Product Change Notification

Change Notification #: 110802 - 00
Change Title: Intel® Server System P4304BTL SFCN, Single, Intel® Server System P4304BTL SHCN, Single, PCN 110802-00, Product Material, Product Material, Chassis design improvement
Date of Publication: June 27, 2011

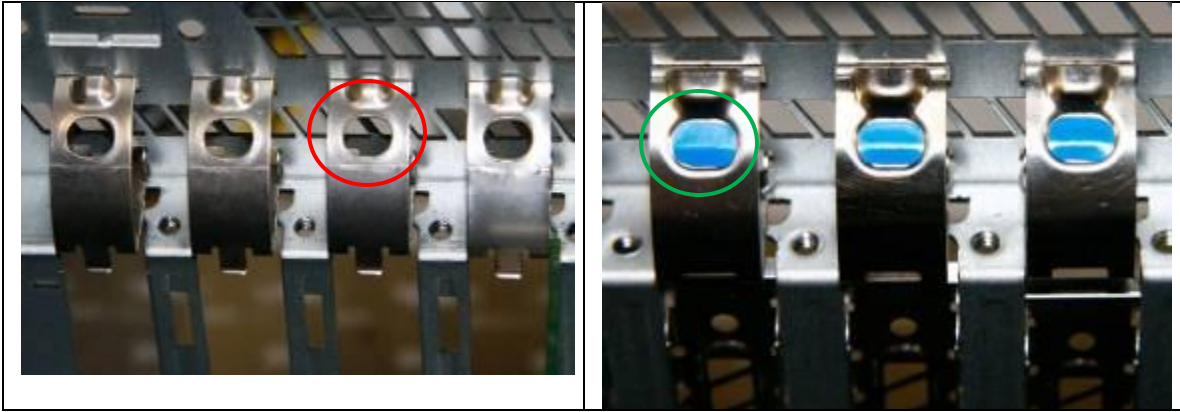
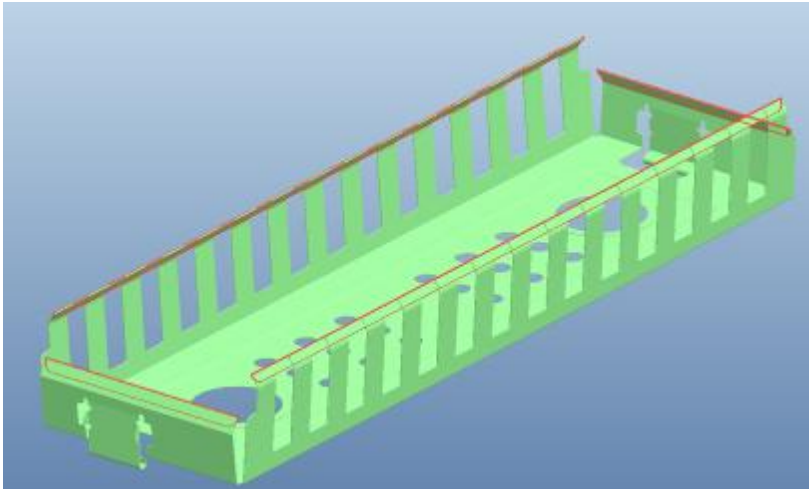
1.2 Fill the PCI retainer hole with an embossment, and add a blue Mylar on the embossment to indicate a user access point. The following are pictures of the prior and post change:

Before the change	After the change
-------------------	------------------

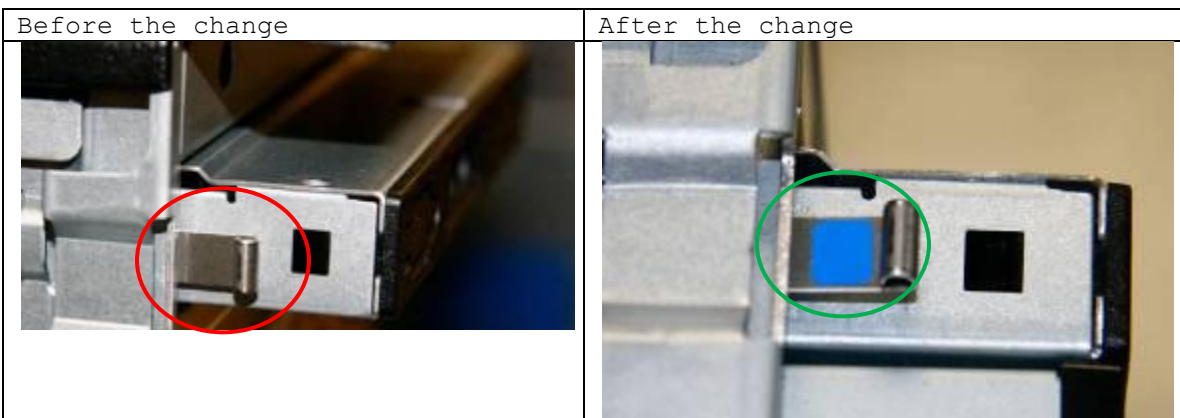
1.3 Add a hem on all edges of Optical Disk Drive (ODD) EMI cover. The following is a picture of the change:

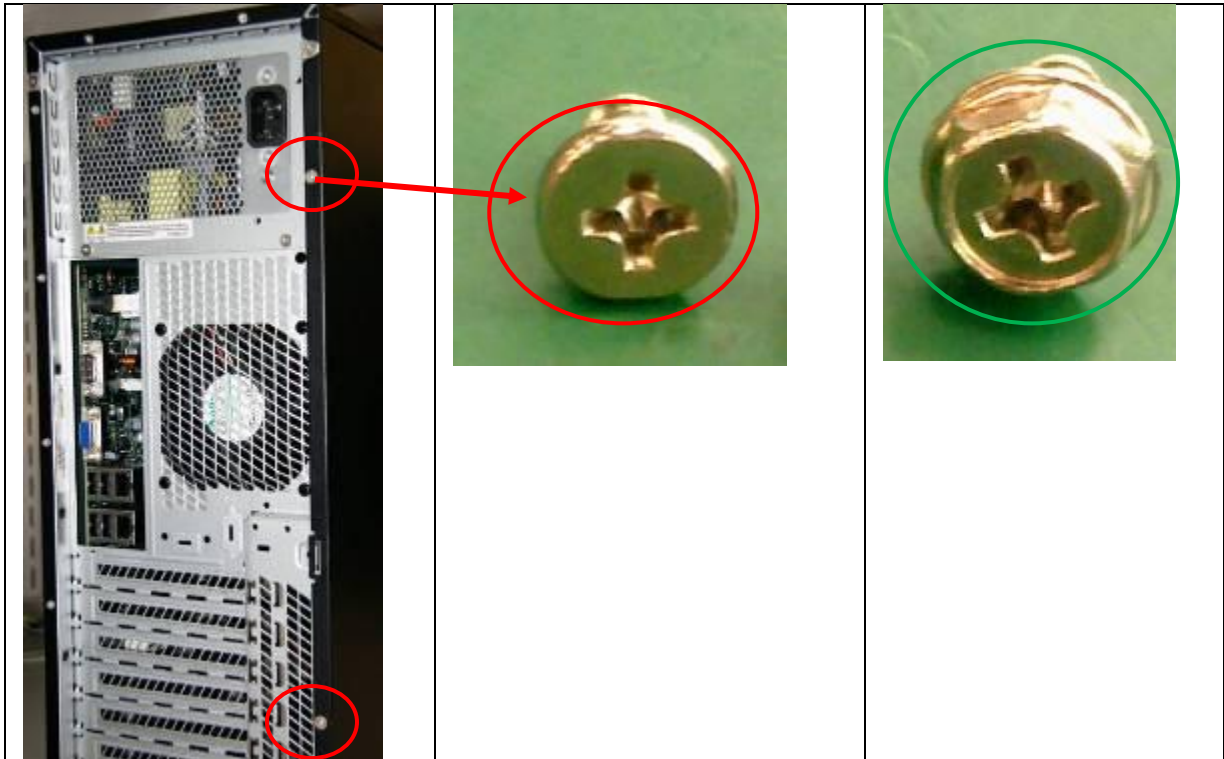
2.3 Change the screws which are used to secure the side covers, to a different head type to differentiate them from other system screws:

The screw locations	Before the change	After the change
